**STATE OF HAWAII
DEPARTMENT OF TRANSPORTATION
HIGHWAYS**

**ADDENDUM NO. 2
FOR
KUHIO HIGHWAY RESURFACING
WAIKAEA BRIDGE TO MAILIHUNA ROAD
FEDERAL-AID PROJECT NO. NH-056-1(063)
DISTRICT OF KAWAIHAU
ISLAND OF KAUAI
April 27, 2023**

This Addendum makes the following amendments to the Bid Documents:

FED. ROAD DIST. NO.	STATE	FED. AID PROJ. NO.	FISCAL YEAR	SHEET NO.	TOTAL SHEETS
HAWAII	HAW.	NH-056-110631	2023	ADD.20	43

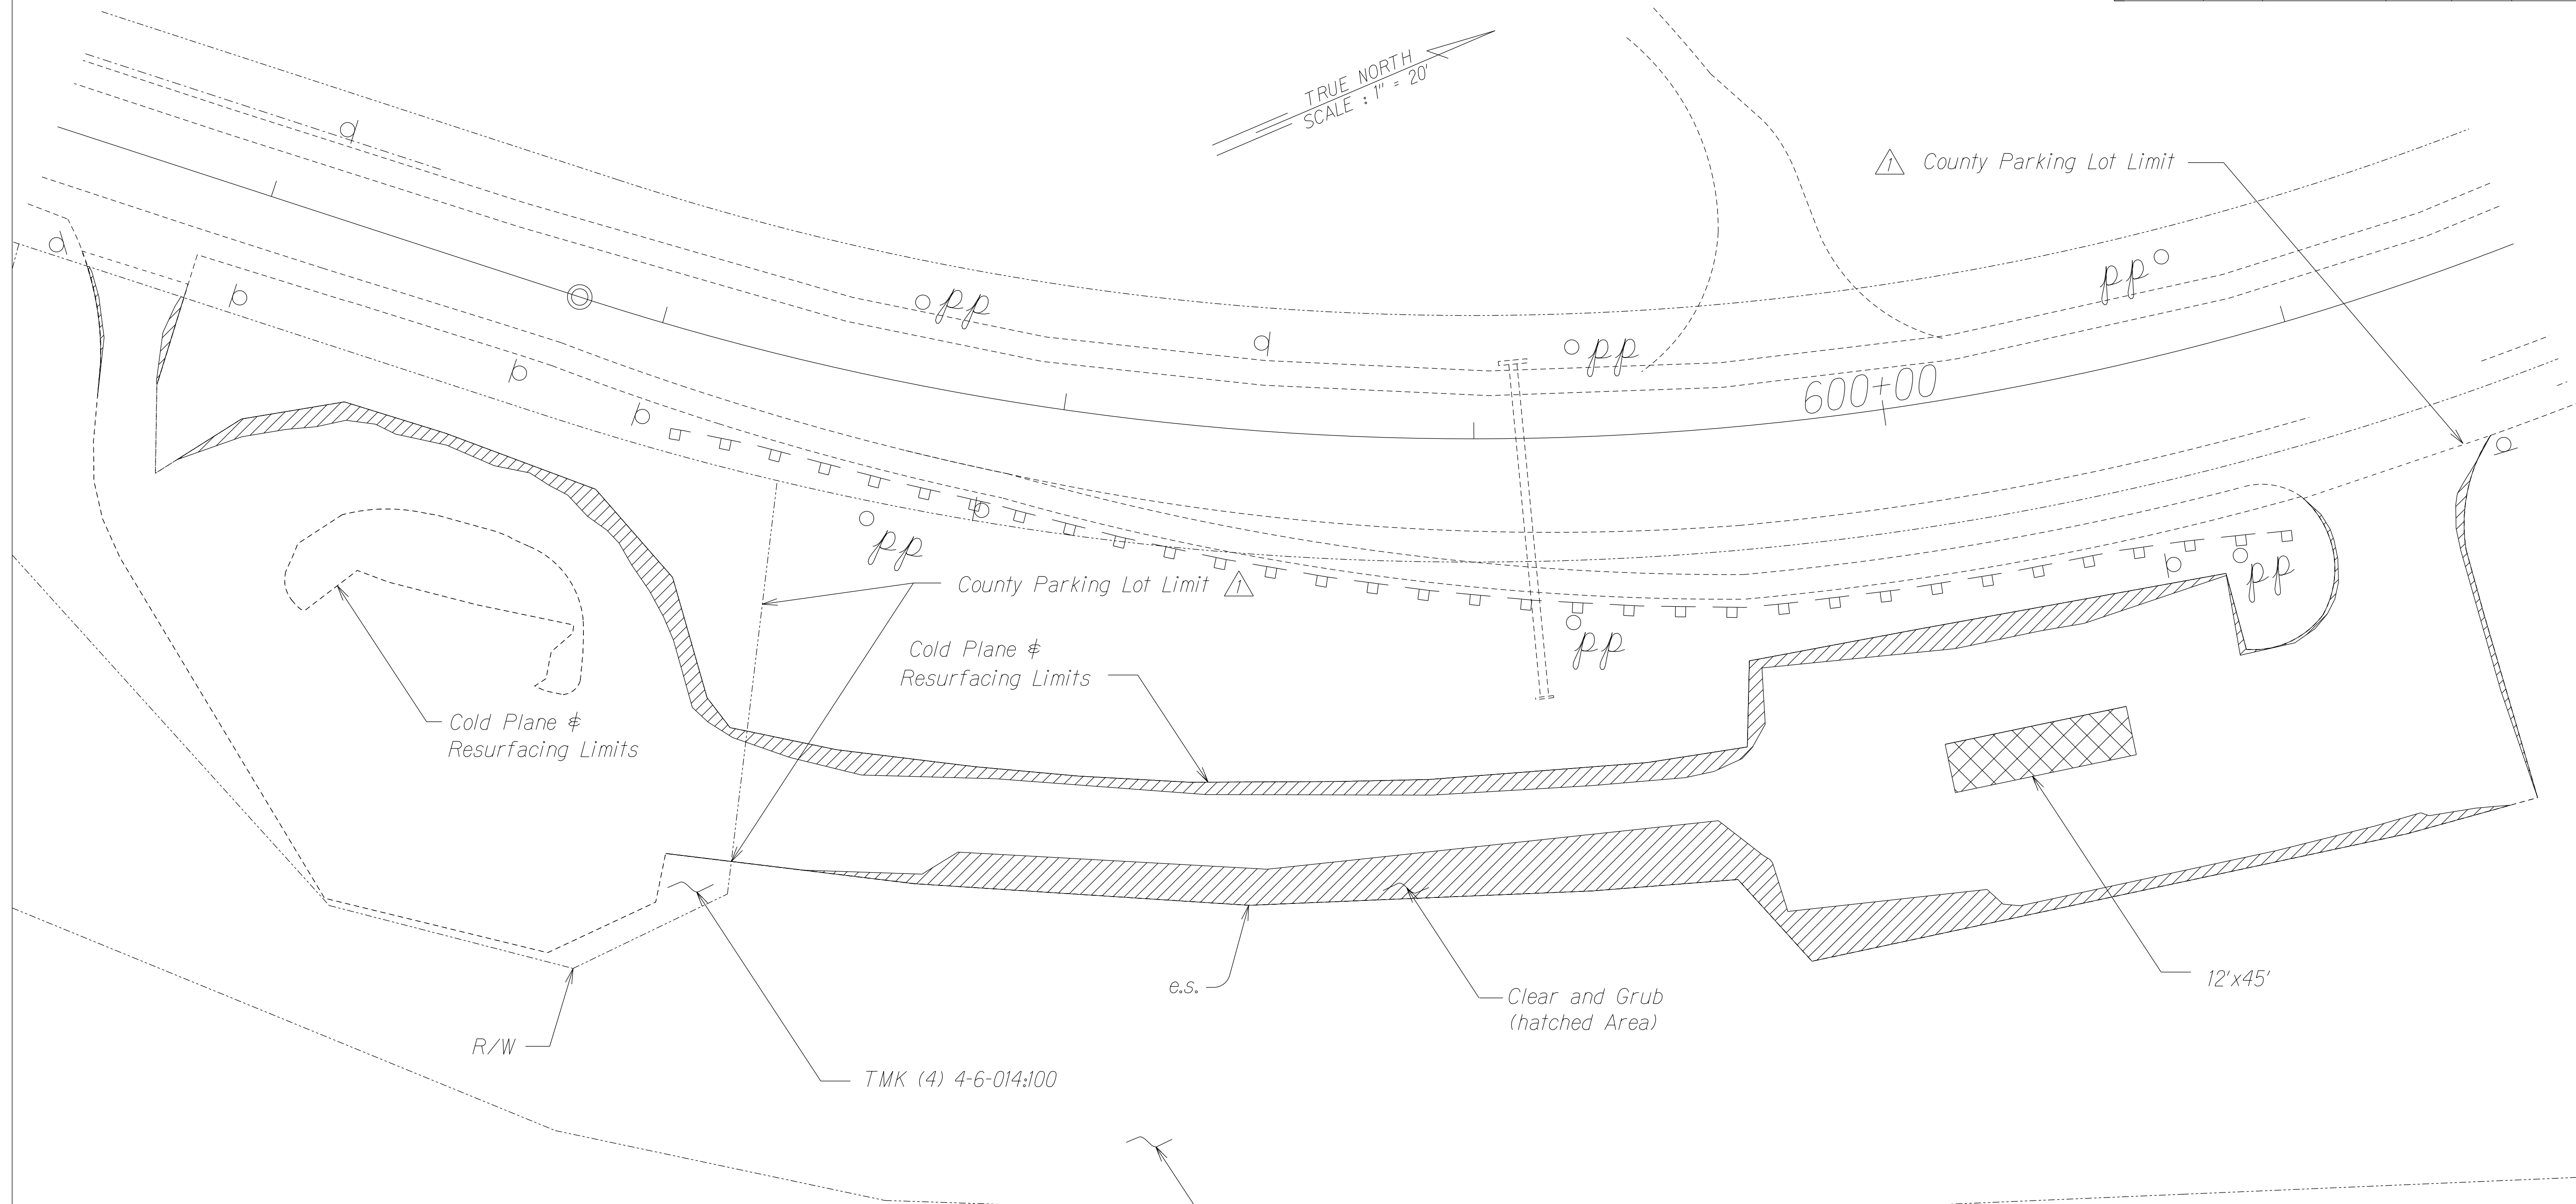
4/25/23	△ - Revision to Callouts
DATE	REVISION
STATE OF HAWAII DEPARTMENT OF TRANSPORTATION HIGHWAYS DIVISION	
ROADWAY PLAN	
KUHIO HIGHWAY RESURFACING Waikaea Bridge to Mailihuna Road Federal-Aid Project No. NH-056-110631	
Scale: 1" = 20'	Date: Mar. 2023
SHEET No. 6 OF 6 SHEETS

20. Please confirm if scaling on Plan Sheet 20 is correct. Dimensions and stations don't match the scale on the bottom right of the page.

RESPONSE: Scale has been adjusted.

RECTANGULAR RAPID FLASHING BEACON
Not To Scale

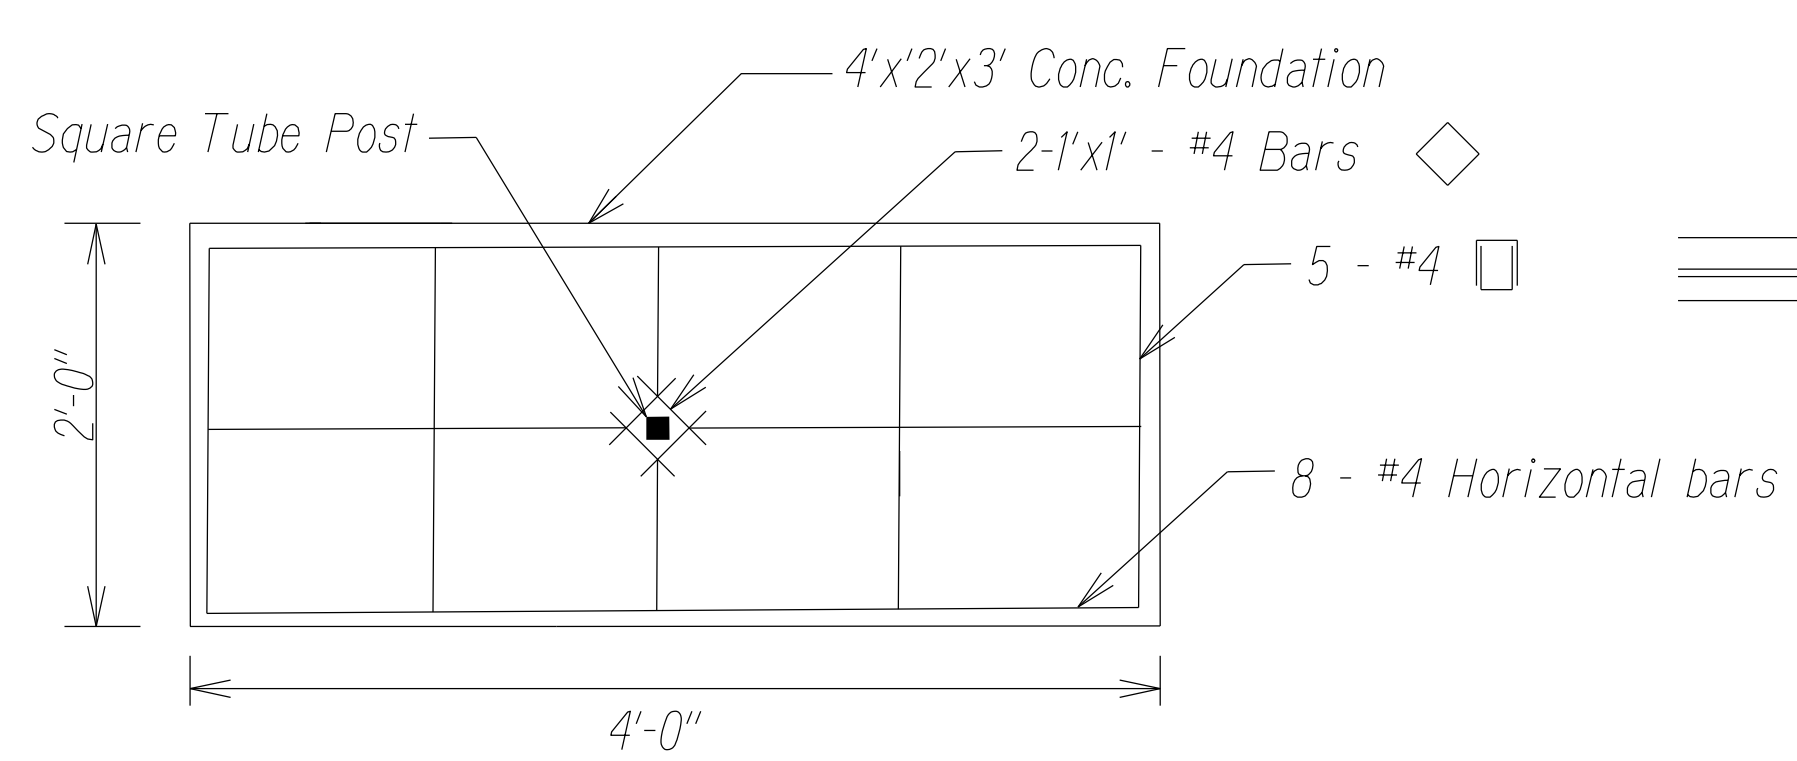
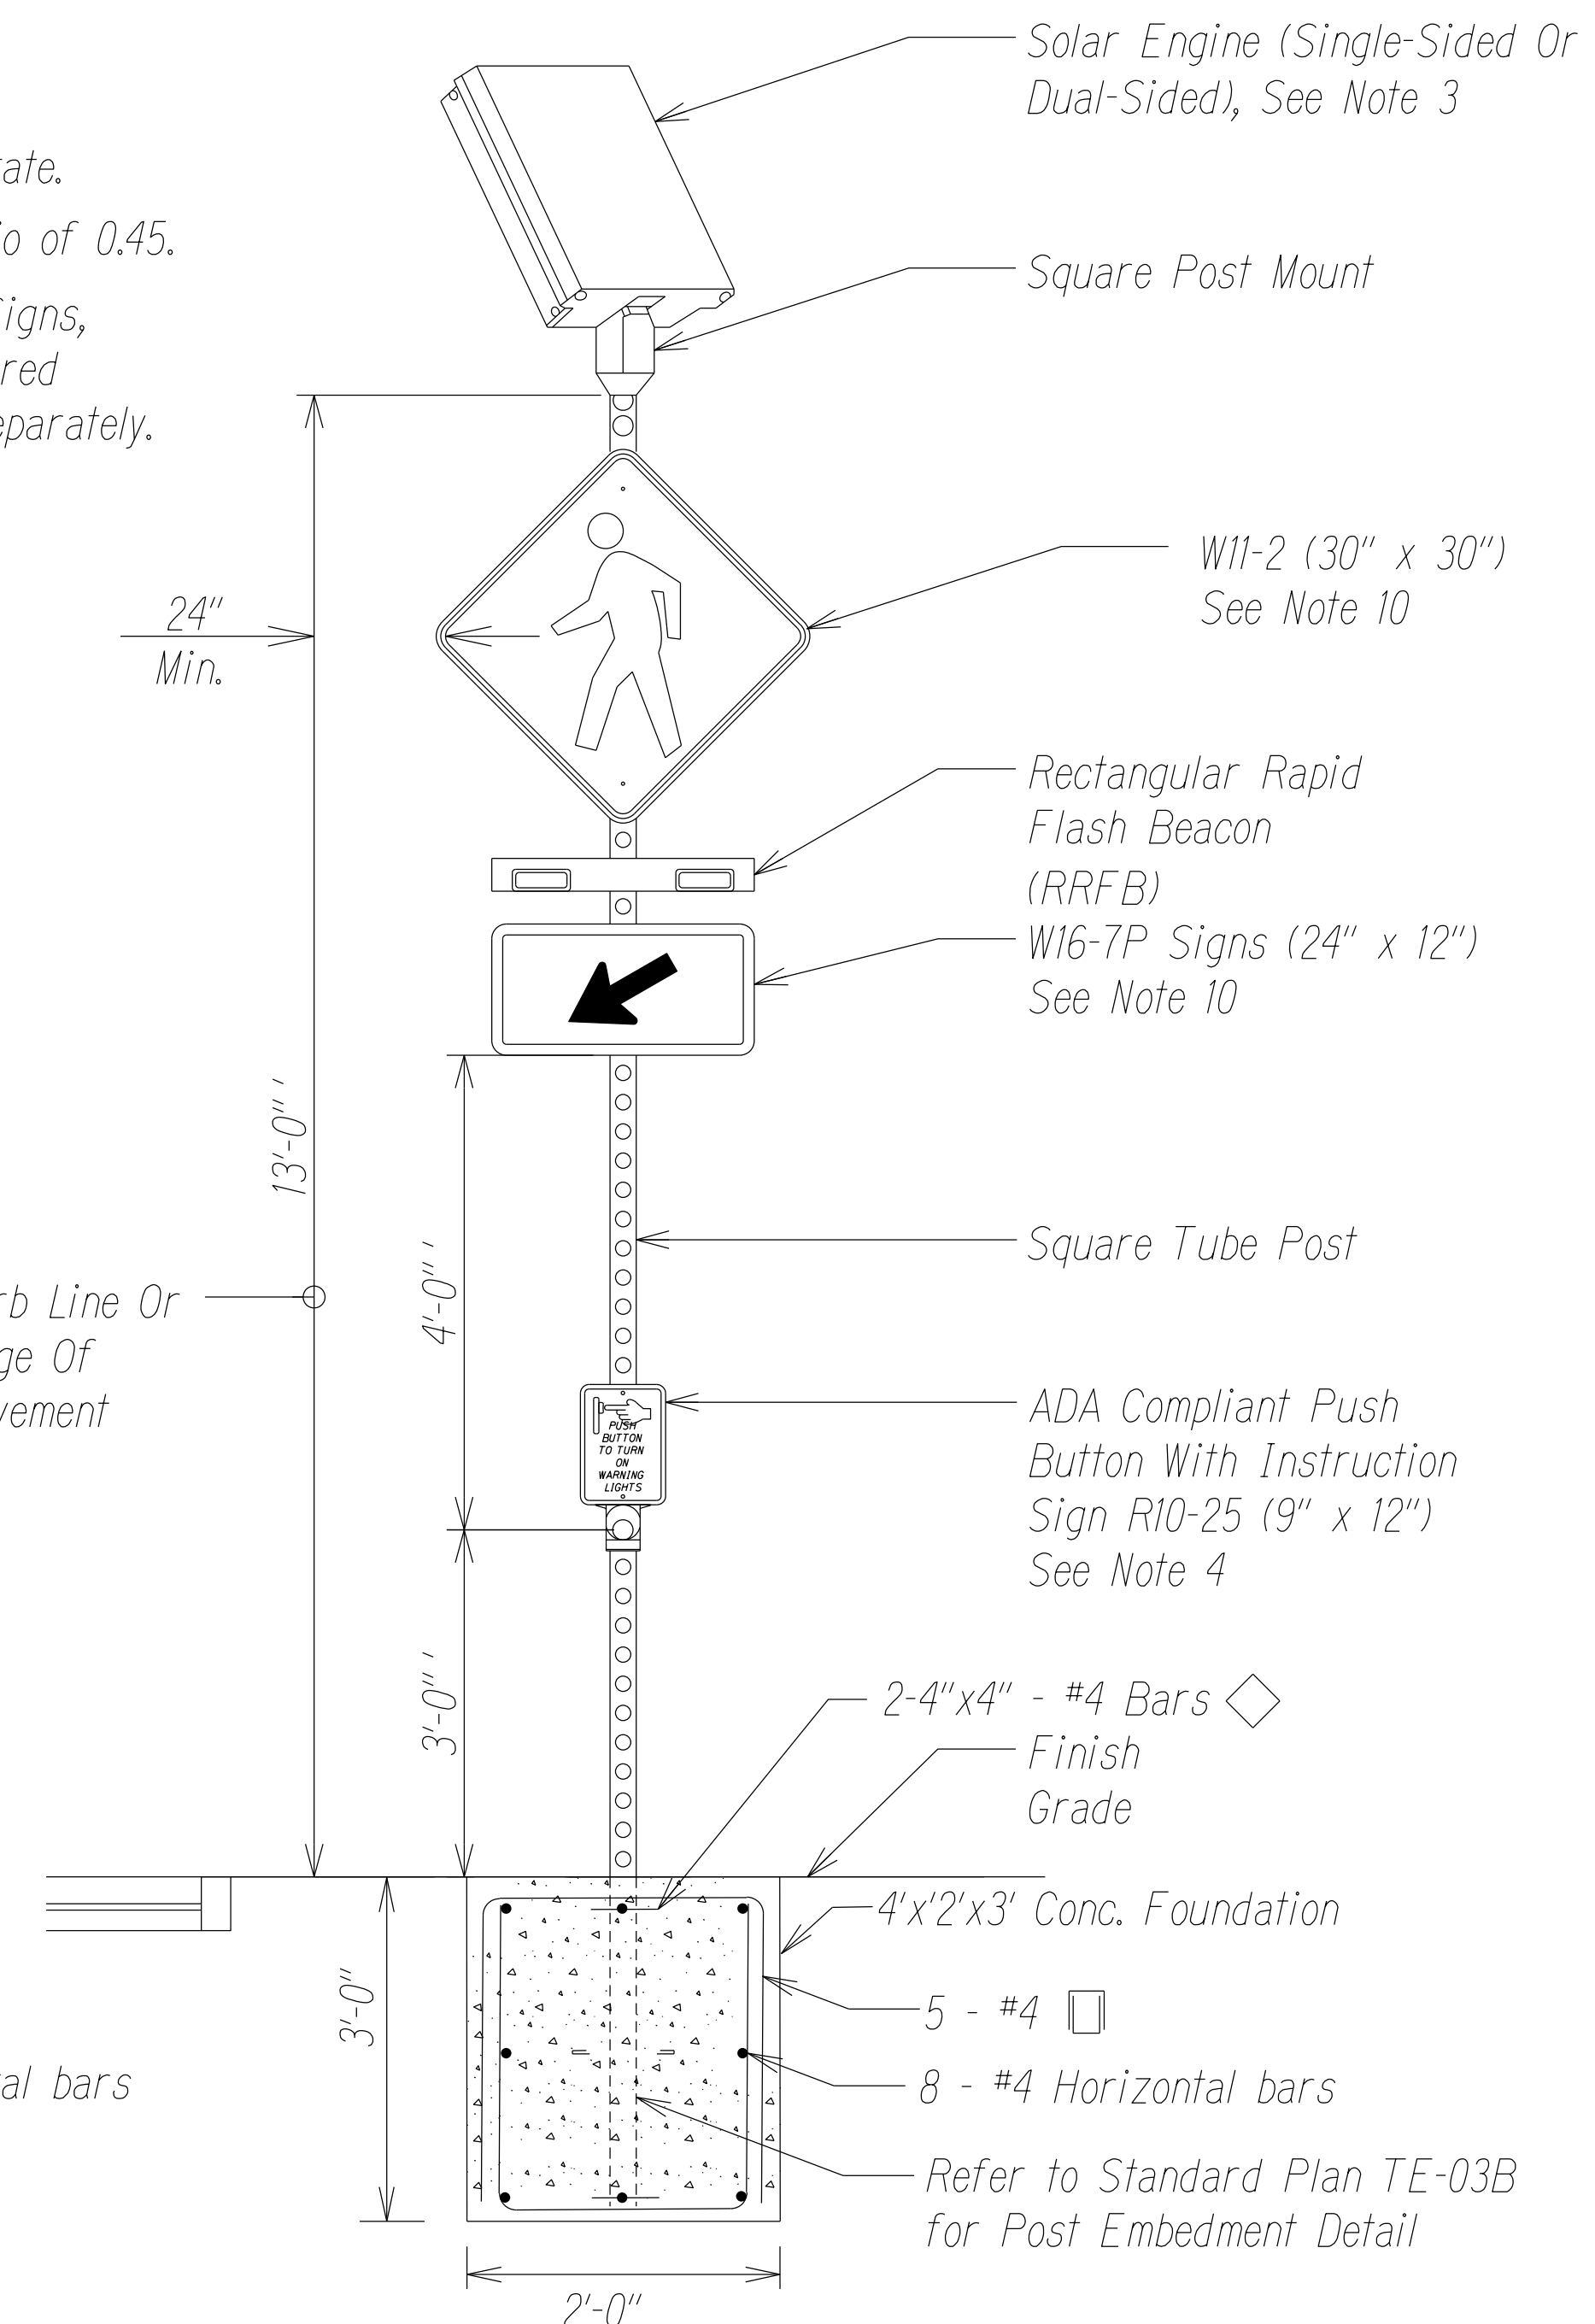
4/21/23	△ - Revise Rectangular Rapid Flashing Beacon Details and Notes
DATE	REVISION
STATE OF HAWAII DEPARTMENT OF TRANSPORTATION HIGHWAYS DIVISION	
PAVEMENT MARKING LEGEND, DETAILS, NOTES & SUMMARY	
KUHIO HIGHWAY RESURFACING Waikaea Bridge to Maillihuna Road Federal-Aid Project No. NH-056-1(063)	
Date: April 2023
